City Planning Commission  
Sacramento, California

Subject: Special Permit extension for a 60,000 sq. ft. television broadcast studio and office in the MRD-PUD zone (P85-257).

Location: Northeast corner Gateway Oaks Drive and Venture Oaks Way.

APPLC. NO. P85-257

# SITE PLAN

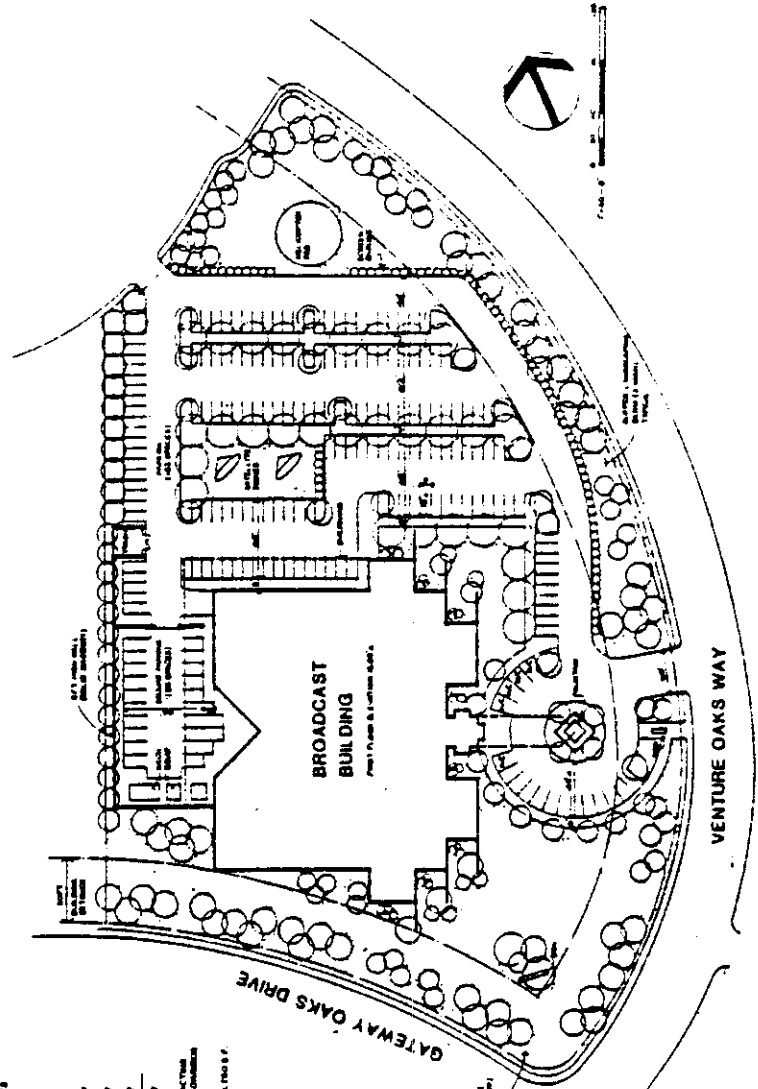
- F. Parking/Circulation: The applicant's site plan indicates that the parking calculations have been based upon the net square footage and not the gross square footage as is required by the Zoning Ordinance. The proposed broadcast facility contains 59,500 square feet of gross floor area which, at a ratio of one space per 250 feet of gross floor area, would require that 238 parking spaces be located on site. The site plan indicates that only 203 spaces have been provided, or 35 spaces less than required by ordinance. *Staff feels that the studio can be classified as a warehouse use which would require six parking spaces and reduce the overall parking to 216 or 13 more spaces than are provided on site. Staff feels that warehouse classification for the studios is appropriate only if both studios are utilized for non-audience participation programming. In the event that an audience participation shows are broadcast from either studio, then parking must be calculated at a higher ratio. (staff added)*

The applicant has not indicated what, if any, unique circumstances exist which warrant the granting of a parking variance. A redesign of the parking configuration (30% compact spaces and utilization of helipad site) would in all likelihood provide the necessary parking ratio. Staff recommends that the parking variance be denied.

It appears that the handicapped parking spaces shown on the site plan will not meet code. All handicapped parking must be redesigned and/or relocated so as to comply with all applicable standards.

As proposed, a corner of the building would extend into the height restricted area along Gateway Oaks Drive. Staff recommends that the site plan be revised to locate the building outside of the height restricted area or at least that portion of the upper floors of the building which are greater than 25 feet in height.

- a. detailed landscape plan for the entire project site;
  - b. four-foot high berms along the street frontages;
  - c. relocation of the building so that it does not encroach into the height restricted area along Gateway Oaks Drive;

- d. 238 on-site parking spaces and 12 bicycle storage lockers.
2. The trash enclosure facilities shall be constructed in accordance with the following criteria:

# LANDSCAPE PLANS

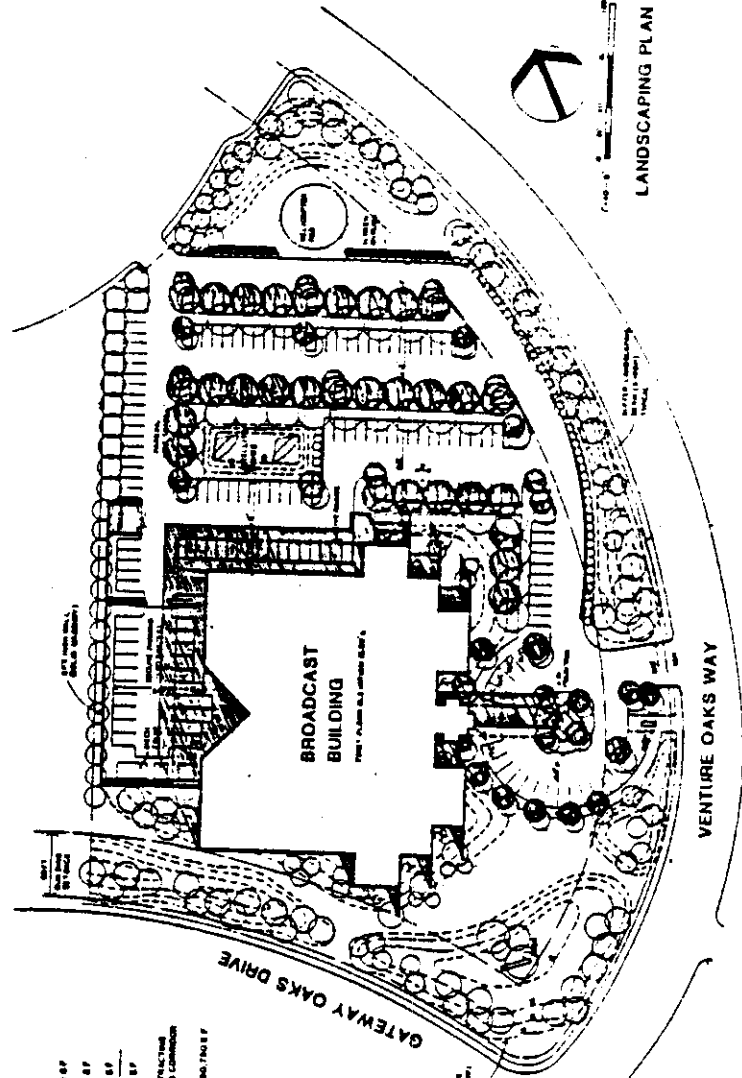
G. Landscaping: The applicant's landscaping plan indicates that 45% of the site will be landscaped. The site plan indicates that the applicant has provided for the required 50 foot and 25 foot landscape setback on Gateway Oaks Drive and Venture Oaks Way, respectively. All landscape setback areas shall be bermed (minimum 4 ft. high) and all berms shall be landscaped with predominantly evergreen trees, shrubs and ground cover. In addition, the parking lot must be planted with trees so that at least 50% of the parking lot will be shaded. A complete landscape and irrigation plan must be submitted to the Planning Director for review and approval prior to the issuance of building permits.

PLAN of SITE & TOWER SITE

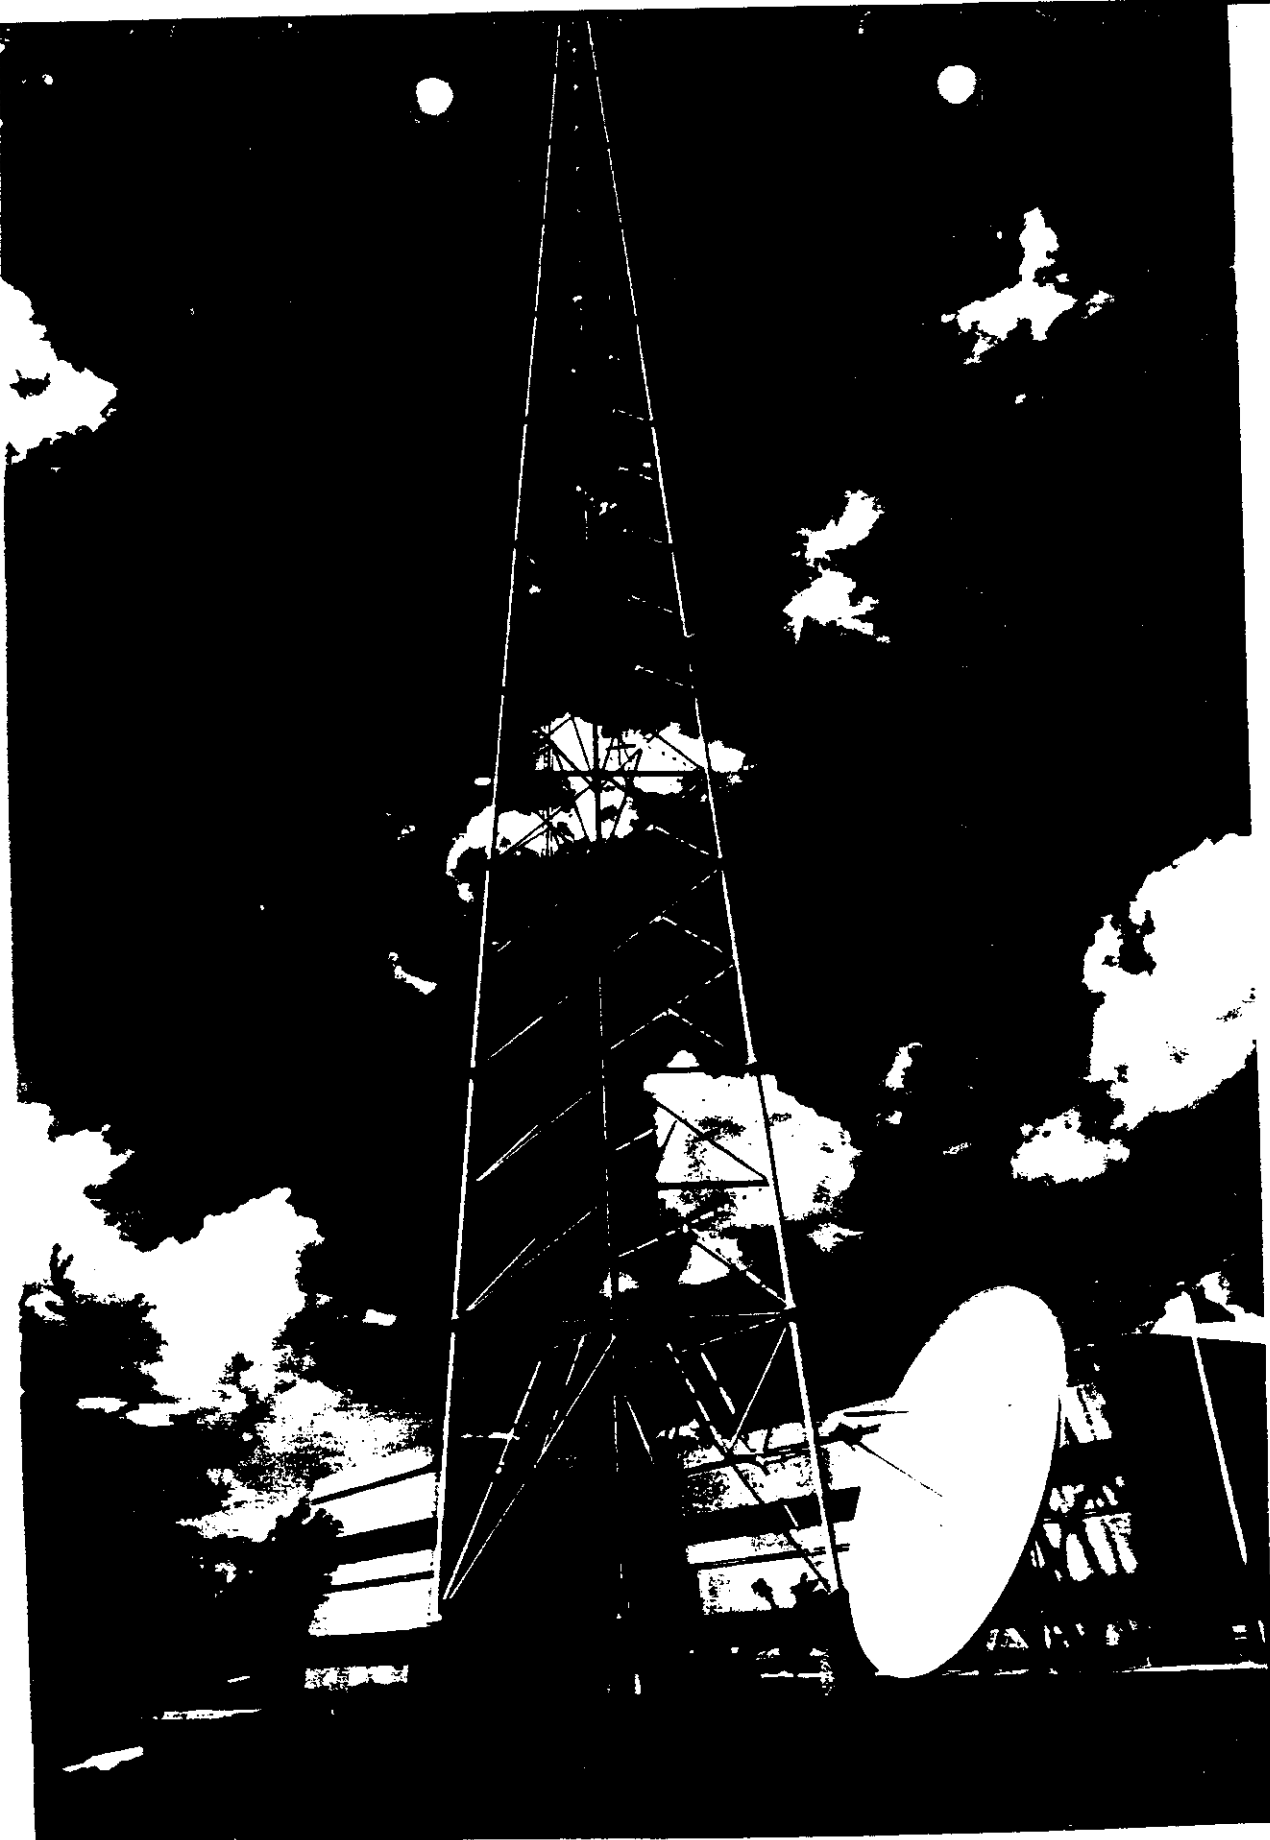
- D. Transmission Tower: The proposed tower would be 300 feet in height. The tower would be located approximately 1,500 feet northwest of the site. The tower would be constructed of tubular steel with a one-story masonry block equipment building located beneath the tower. The applicant has not decided upon a color for the tower; however, it should be noted that the tower does not have to be painted the traditional red and white. Staff recommends that the Design Review Board make the final determination as to the appropriate tower color.

The tower is located in the area designated for such use on the South Natomas Office Park PUD Guidelines. The proposed location is appropriate in that existing electrical transmission towers are located on the site. This site is designated for a 'joint use' transmission tower which shall be shared by all users in the PUD. It is unclear at this point as to whether or not other PUD tenants will require transmission facilities. The applicant has indicated that the tower can accommodate other users (within reasonable limits). The tower site has been reviewed by the County Airport Department and Natomas Air Park. No comments have been received.

- 5. No signage shall be permitted to be placed on the transmission tower.
- 6. The applicant shall submit verification of Federal Aviation Administration approval of the transmission tower site.
